Relevant Information for Central Sydney Planning Committee

FILE: D/2024/446 **DATE:** 8 May 2025

SUBJECT: Information Relevant To Item 8 – State Significant Development Application:
372-382A Pitt Street, Sydney – D/2024/446

Figure 1: proposed ground floor plan with current location of hydraulic booster and proposed relocation

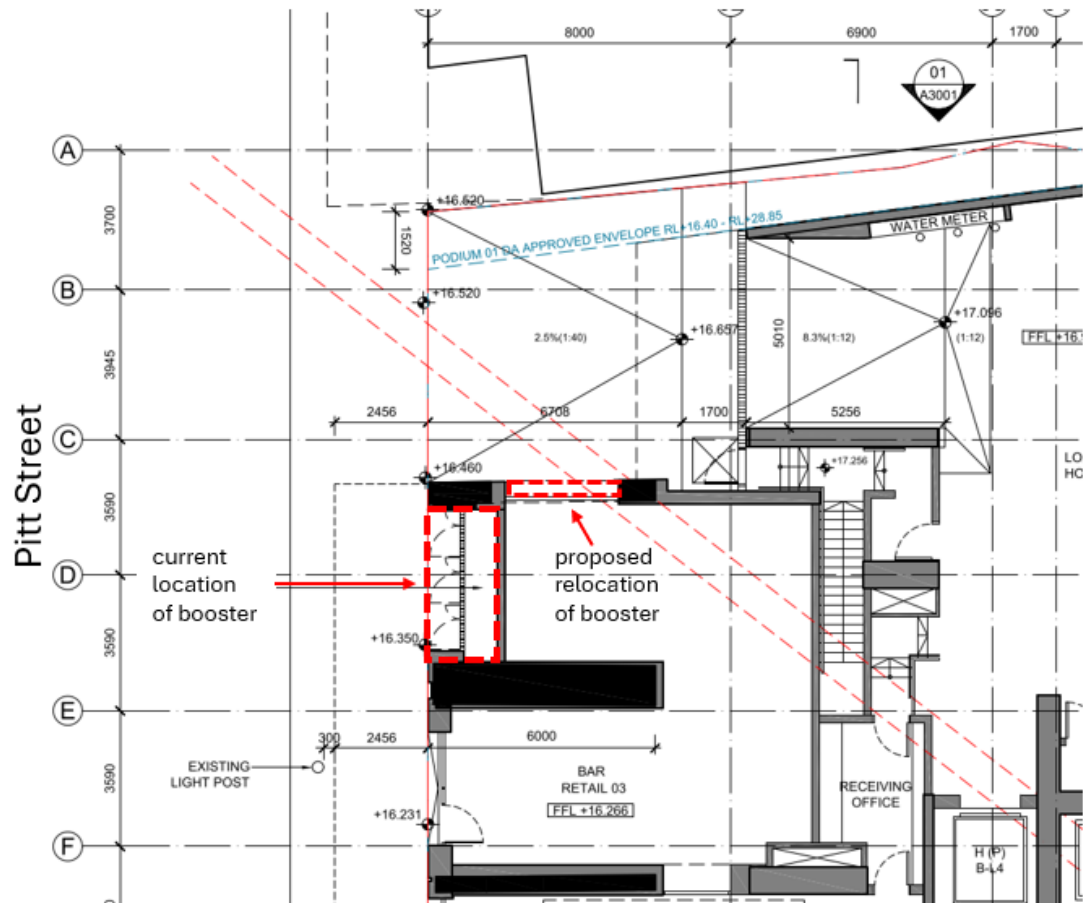
The applicant has also requested that subsection (b) be deleted for the following reasons:

- the driveway location for the hydraulic booster is not suitable as the driveway appears to be only 5m wide, where Fire and Rescue NSW (FRNSW) requires a

minimum 6m wide hardstand area; and there does not appear to be sufficient space to manoeuvre a fire truck.

The deletion of subsection (b) in relation to the relocation of the hydraulic booster is not supported. A hydraulic booster occupying a full shopfront bay facing Pitt Street is a poor urban design outcome as it will limit ground floor activation. Additionally, the applicant has not provided correspondence from FRNSW confirming that the location is unsuitable.

The condition requests the booster be relocated from the Pitt Street elevation to the northern elevation / side wall of 374 Pitt Street, facing the driveway. The location is setback 2.1m from the Pitt Street boundary of the site.

The *Fire Safety Guideline Access for Fire Brigade Vehicles and Firefighters* by FRNSW requires a driveway width to be a minimum 6m if a fire safety vehicle is required to enter the site, to allow easy negotiating by the vehicle and provide room around the vehicle to allow firefighters to exit and use equipment (Guideline 7.1). The hardstand area utilised by the vehicle is to be within 8m of any fire hydrant booster assembly (Guideline 8.2).

A fire safety vehicle is expected to stop in front of the site on Pitt Street to access the hydraulic booster in its current location and given the close proximity of the booster to the boundary if relocated, will likely still utilise Pitt Street for access rather than the driveway. The fire safety vehicle, if stopped on Pitt Street, is located approximately 5.2m from the relocated booster.

Figure 2: proposed photomontage indicating where relocated hydraulic booster is to be situated

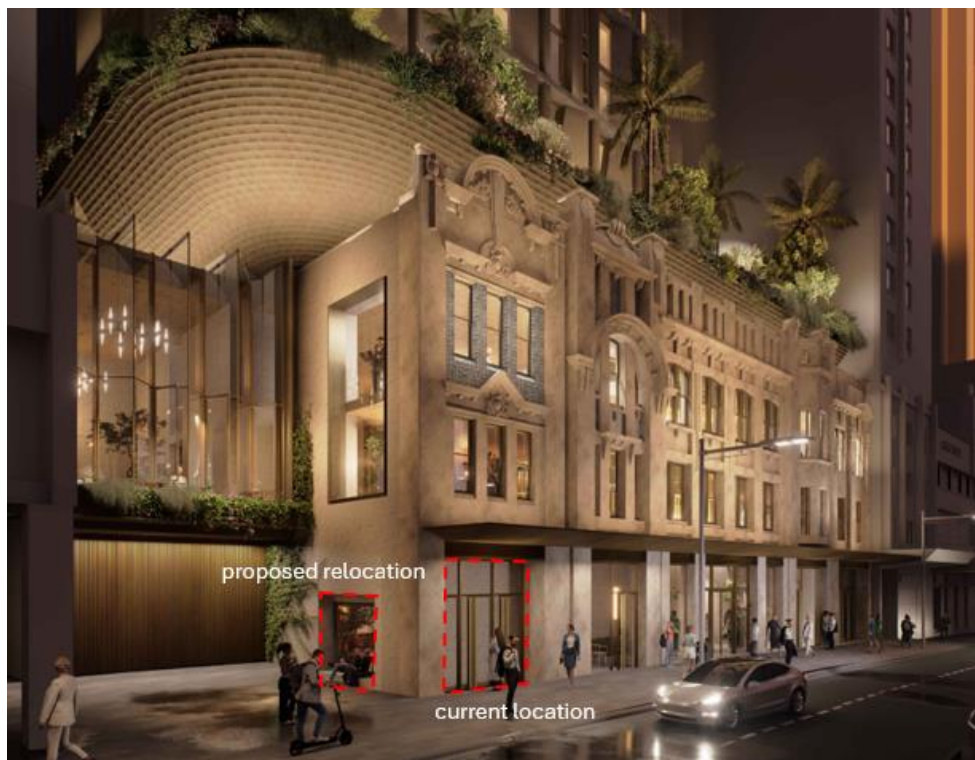
The condition also requires the relocation of the hydraulic booster from the Pitt Street elevation to the northern elevation/side wall of 374 Pitt Street at ground floor, facing the driveway. The condition is reproduced below:

Figure 49 – 1914 proposed alterations to the shopfront at 372 Pitt Street.

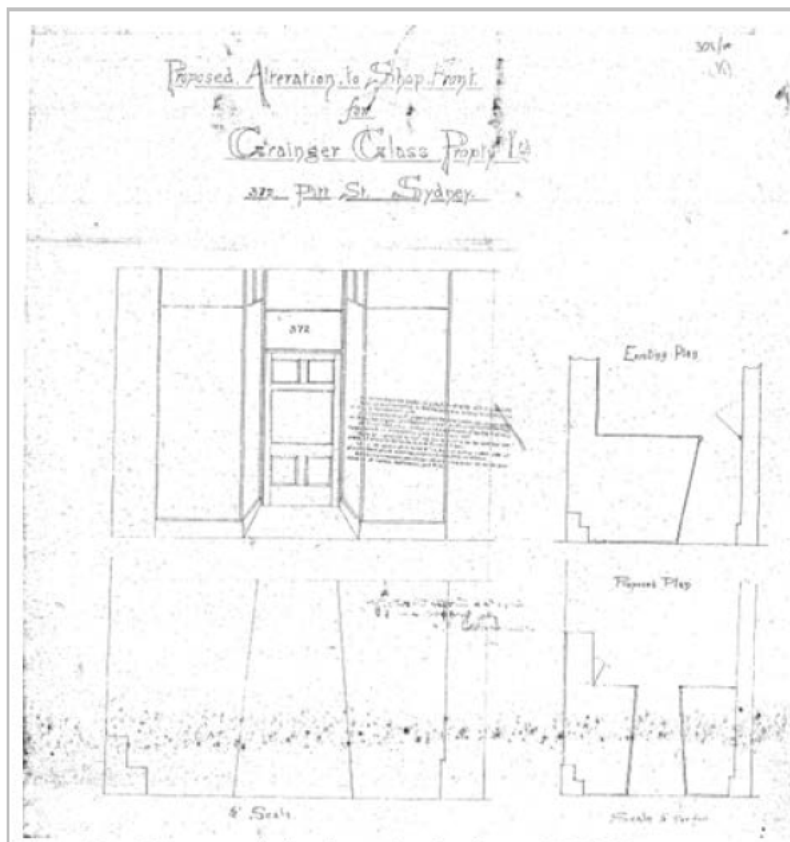
I have also replicated HIS Figure 49 below which I don't think is the correct reference as it shows previous alterations approved to the shopfront?

Rather than delete subsection (a) completely, it is recommended that the condition be re-worded to state that all ground floor shopfronts be reconstructed to interpret their original configuration and form “where possible” to provide a level of flexibility to the interpretation of the shopfront.
